SUBJECT: TECHNICAL REVIEW OF FINAL INVENTORY DOCUMENTATION
FOR TANKS 5 AND 6 AT F-TANK FARM, SAVANNAH RIVER SITE,
(PROJECT NO. PROJ0734)

Technical Review of Final Inventory Documentation Supporting F-Area Farm, Tanks 5 and 6 Closure

Date: September 25, 2013

Figure 1 Residual Tank Waste Sampling Approach

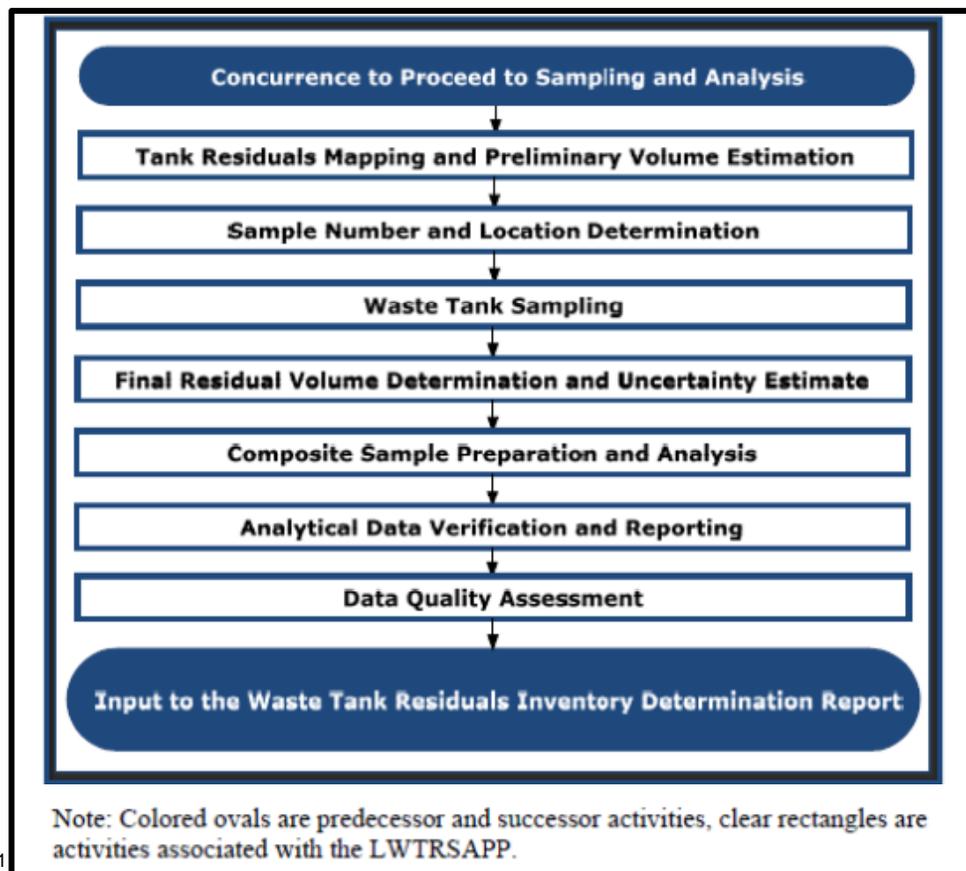
As a result of the review of SRR-CWDA-2011-00050, Revision 1, NRC staff had a number of questions that it posed to DOE during the March 27-28, 2013, onsite observation (see onsite observation report, ML13113A322). Most notably, NRC inquired about the basis for the number of samples per composite (five samples) and the number of composites to be analyzed (three composites). DOE indicated that the waste is expected to be well mixed such that five samples are sufficient to capture variability within the tank. DOE also indicated that three composite samples are needed to get good statistics on composite sample variability. DOE provided in-process volume mapping illustrations during various stages of waste retrieval to demonstrate that the solids are well mixed. DOE stated that it was not asserting that the residual waste is homogeneous, but rather that the waste is well mixed throughout the tank.

Figure 3 Distribution of Solid Residuals Following Initiation of Oxalic Acid Chemical Cleaning in Tank 5

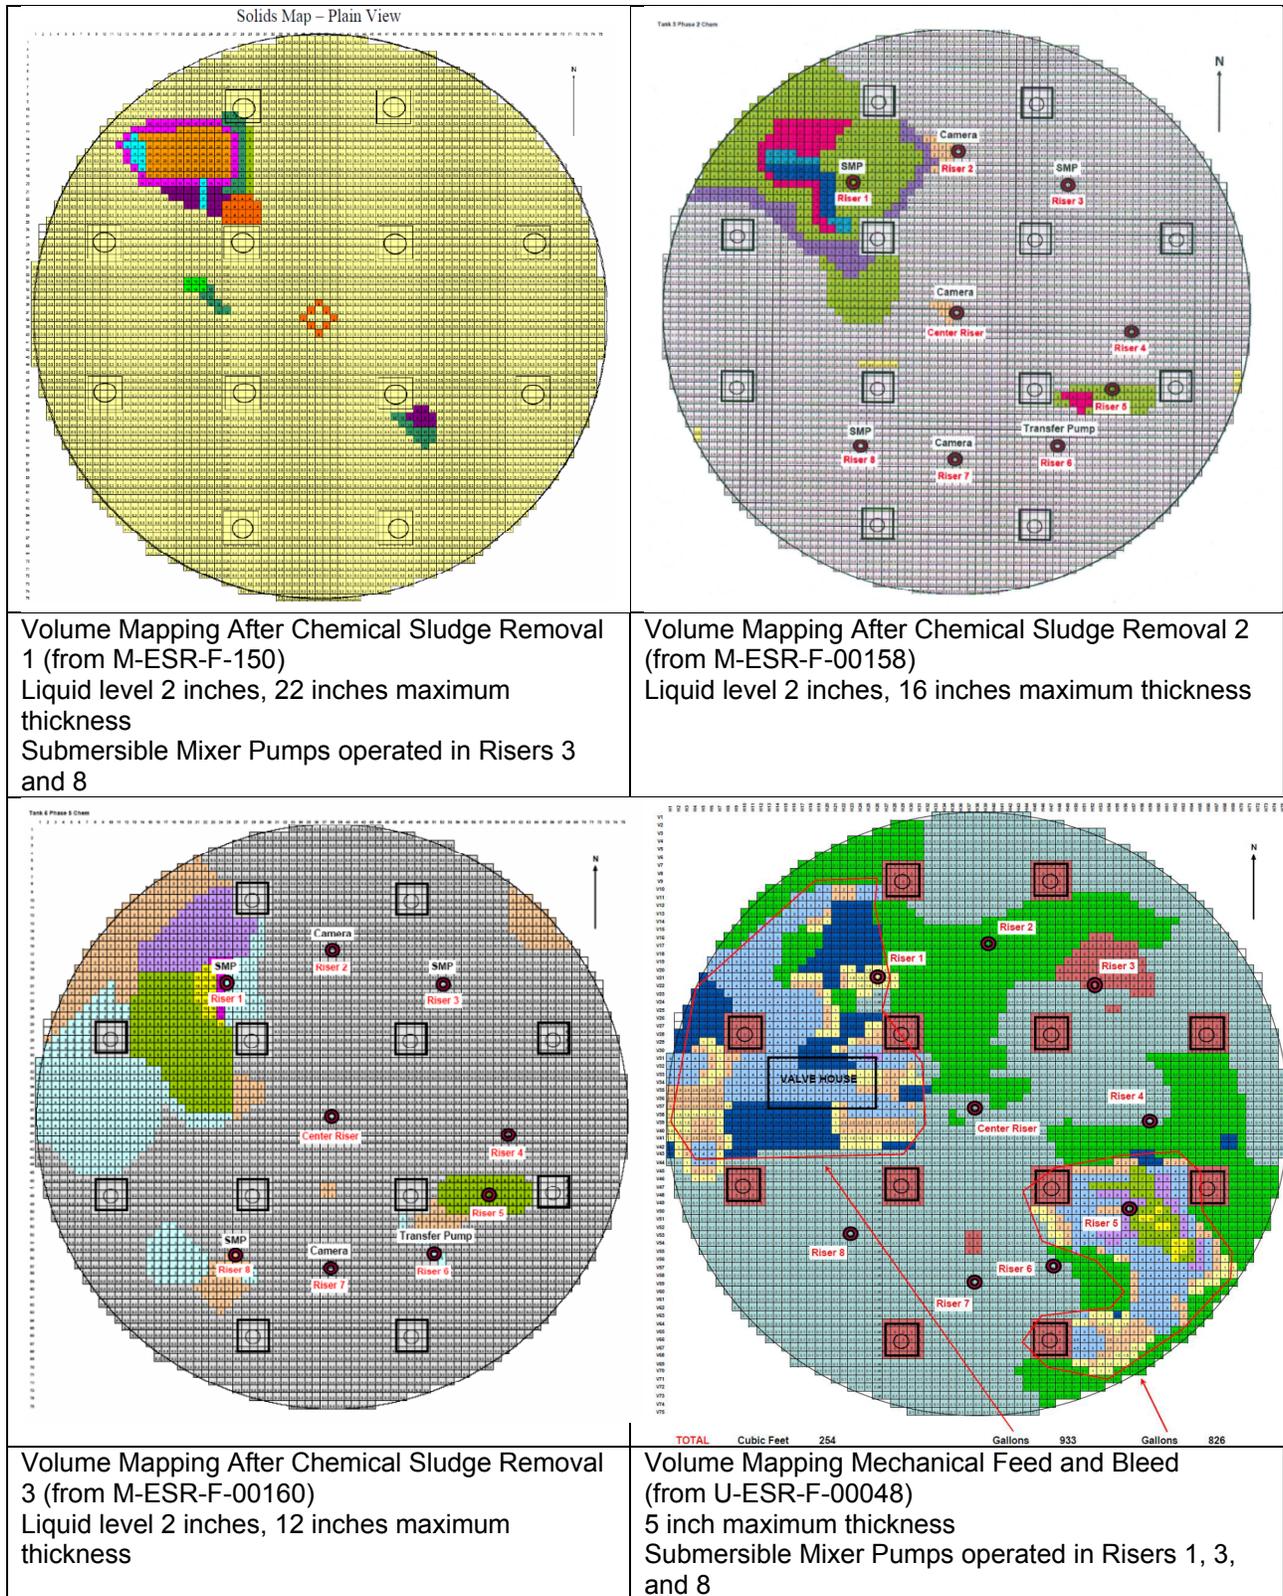
The impact of cleaning operations on the alteration and redistribution of sludge residuals should be considered in the sampling plan and design. While the solids in Tank 5 may have been well mixed during various stages of sludge removal, it is not clear that the solids were well mixed at the end of cleaning operations⁴. For example, the Riser 1 solids that were mobilized during mechanical sludge removal accumulated near Riser 1 during the first oxalic acid strike likely because the Riser 1 Submersible Mixing Pump (SMP) was not used during chemical cleaning (see Figure 3). Although a Submersible Mixing Pump was operated in Riser 1 during mechanical feed and bleed and the Riser 1 accumulation was reduced and flattened by the end of cleaning operations, the accumulation near Riser 1 persisted from the end of the first chemical cleaning strike to the end of mechanical feed and bleed (see Figure 3). Challenges experienced during chemical cleaning led to the formation of metal oxalates that are thought to have hampered subsequent chemical cleaning campaigns in Tanks 5 and 6. Oxalate precipitates that may have made it more difficult to treat tank sludge, could have also led to differences in radiological composition between waste in more direct contact with oxalic acid and waste that was buried in tank accumulations. While material at the bottom of the tank

accumulations appears to have been mobilized to a certain extent during mechanical feed and bleed, access limitations that constrained sample collection and the limited number of mound samples that were composited with other tank samples makes it perhaps more challenging to obtain information on variability between or within segments that could exhibit heterogeneity (e.g., waste residual mounds could be more heterogeneous compared to thin accumulations across the tank; the inner, bottom portion of a mound could be heterogeneous relative to the outer, top portion of a mound).
